Energy West Mining Company  
P. O. Box 310  
15 No Main Street  
Huntington, Utah 84528

September 19, 2014

**Subj: Amendment to Volume 9 Text Section, Volume 9 Appendix A, and Volume 9 Maps Section in Response to the Reduction in the Hydrologic Monitoring Program, PacifiCorp, Wilberg/Cottonwood Mine C/015/0019, Deer Creek Mine C/015/0018, , Emery County, Utah.**

CE-10404-EM  
DRAWING #:  
SHEET 1 OF 1  
REV. ---

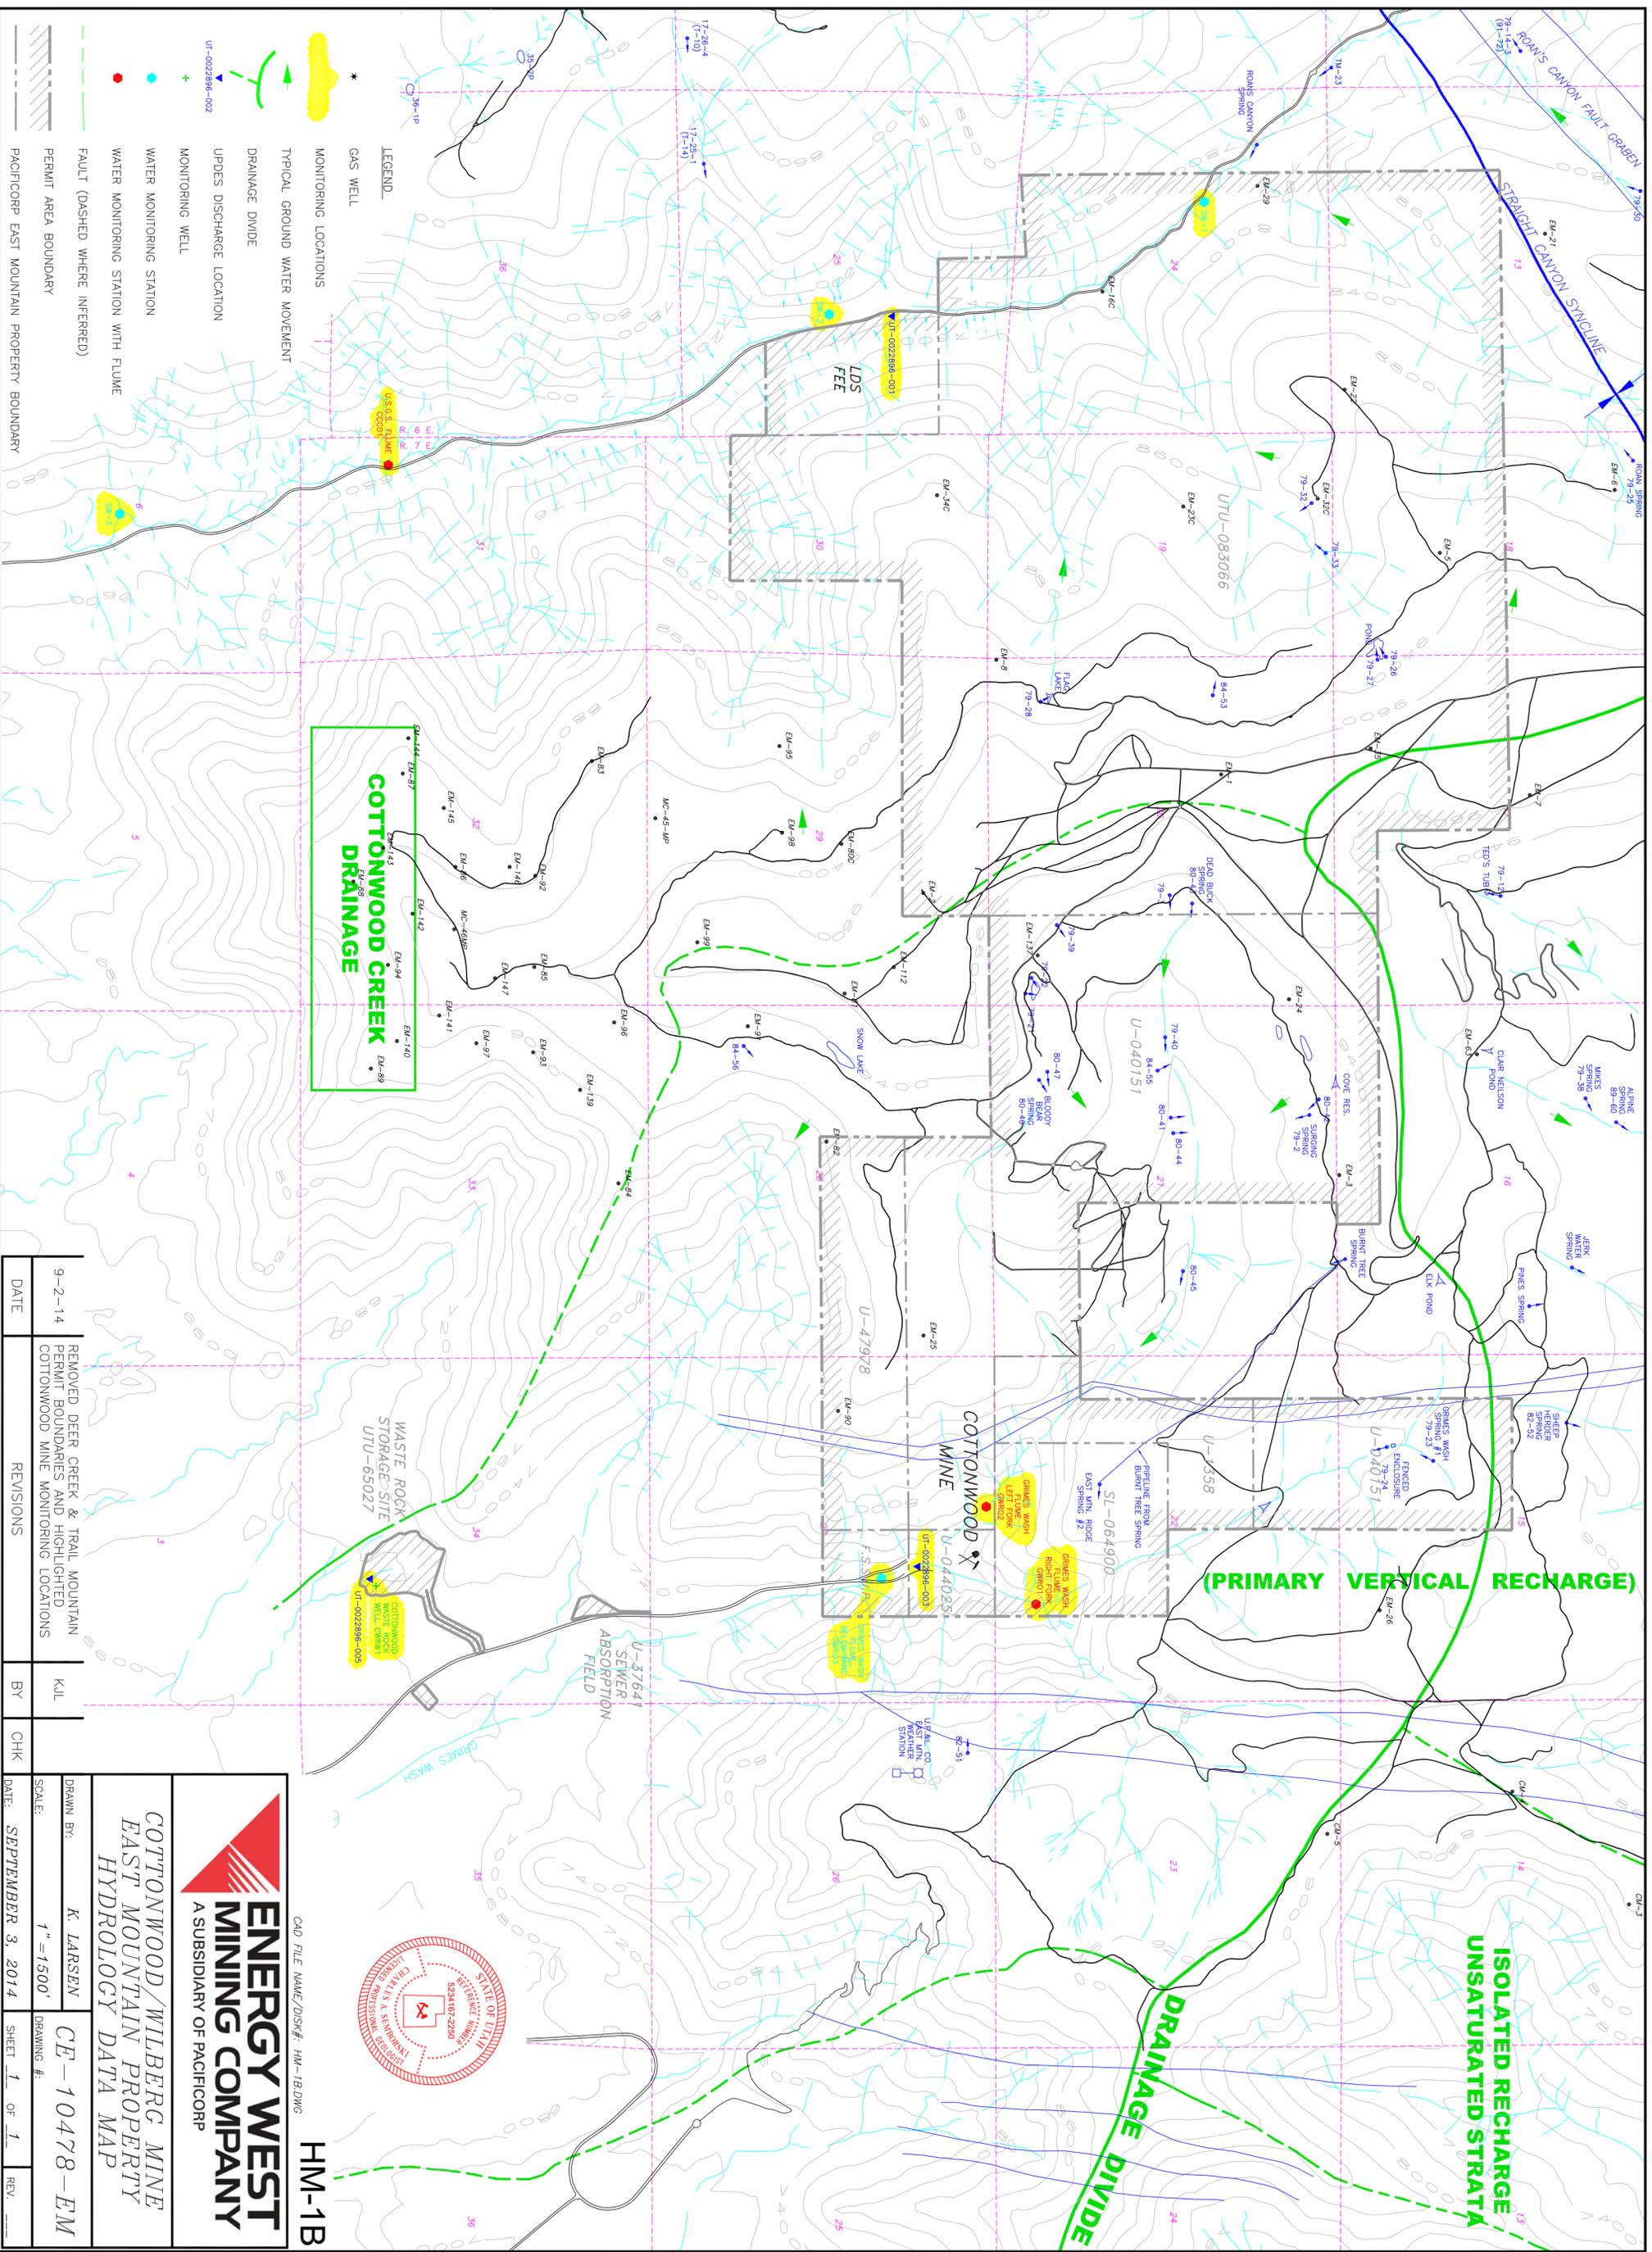
Replace HM-4
